ADDENDUM NO. 2

**PROJECT NAME:
CONEJO CREEK SOUTH PARK
IRRIGATION PROJECT**

April 21, 2026

L-2.04

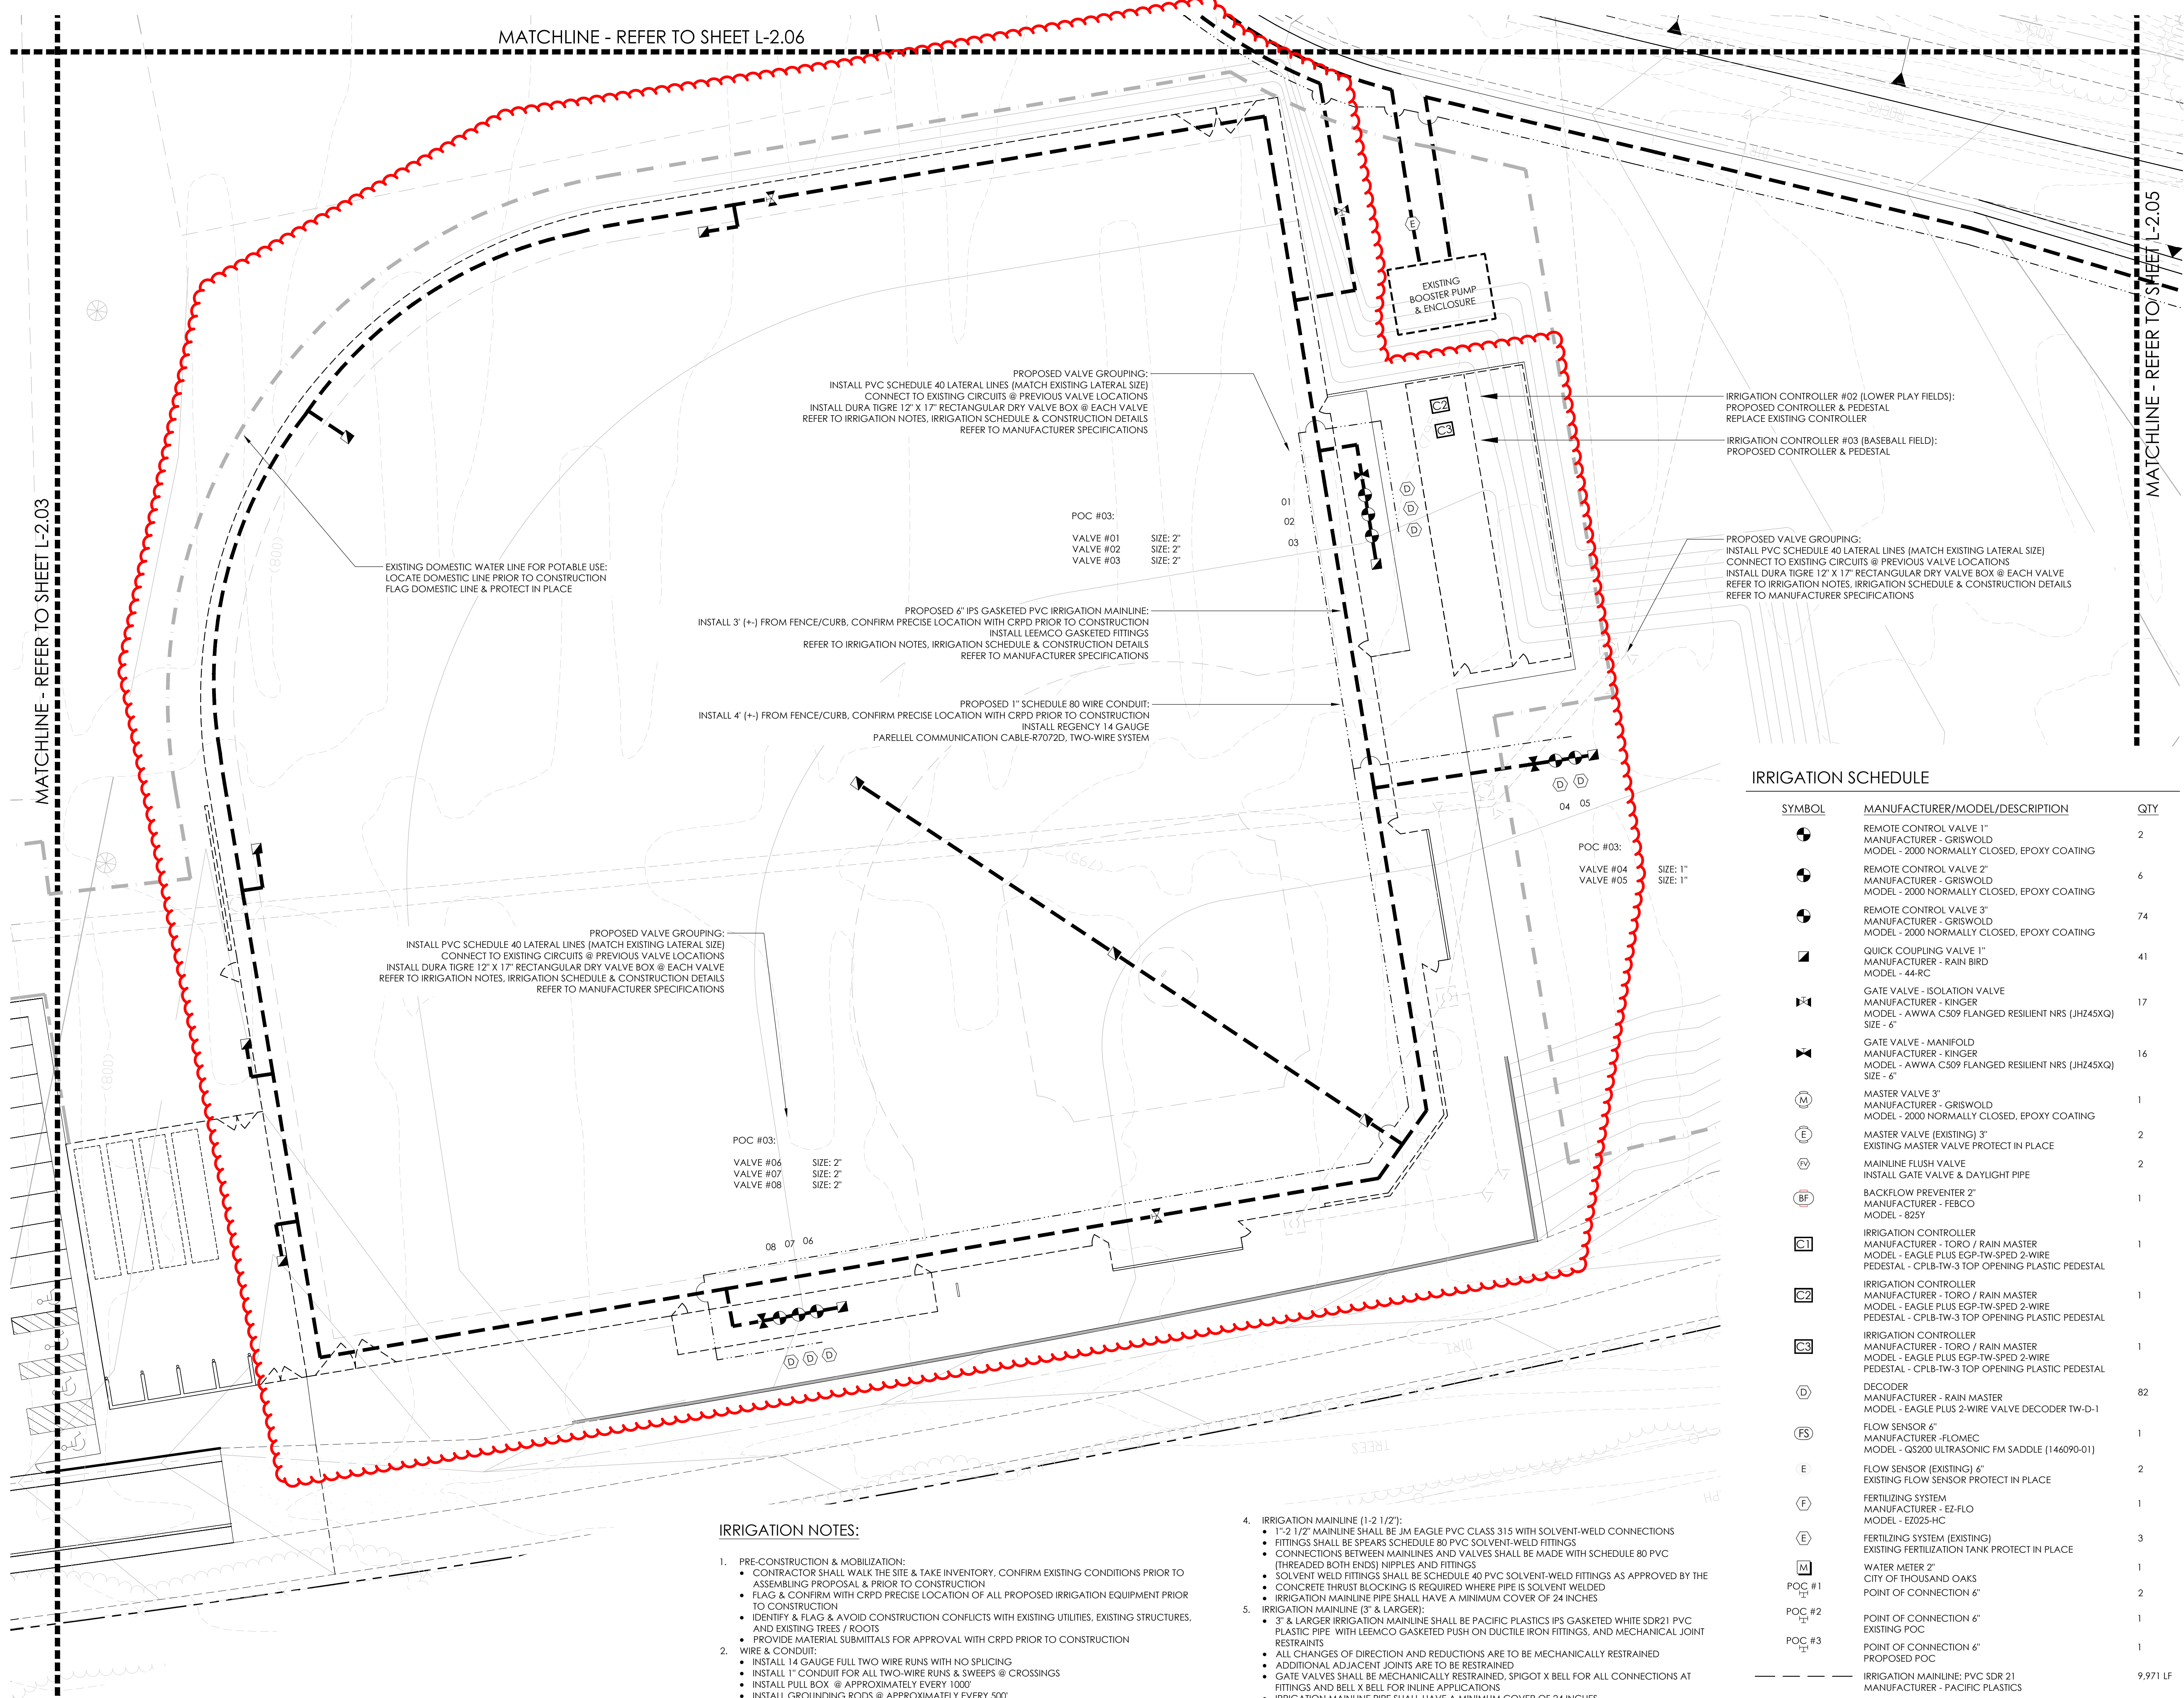
See attached Base Bid Plan Sheet Nos. L-2.04 and L-2.06 denoting Add Alternate scope of work; see RFI Section, Question and Answer No. 4 for written explanation.

Question 5: The Base Bid Plan Set, Sheet No. L-2.06, shows a water meter in the Public Right-of-Way, but no detail or model is provided. Please clarify if the meter is to be Contractor Furnished—Contractor Installed (CFCI), or Owner Furnished—Contractor Installed (OFCI). If CFCI, please provide the required make and model.

Answer 5: The meter included in the Add Alternate scope will be CFCI. Please disregard any meter installation details listed on Sheet Nos. L-2.04 and L-2.06 that include the water meter installation, main line run, and any detail associated with the Add Alternate plan. The revised work (see clouded notations on Sheet Nos. L-2.04 and L-2.06 attached) shall be included in the Add Alternate scope.
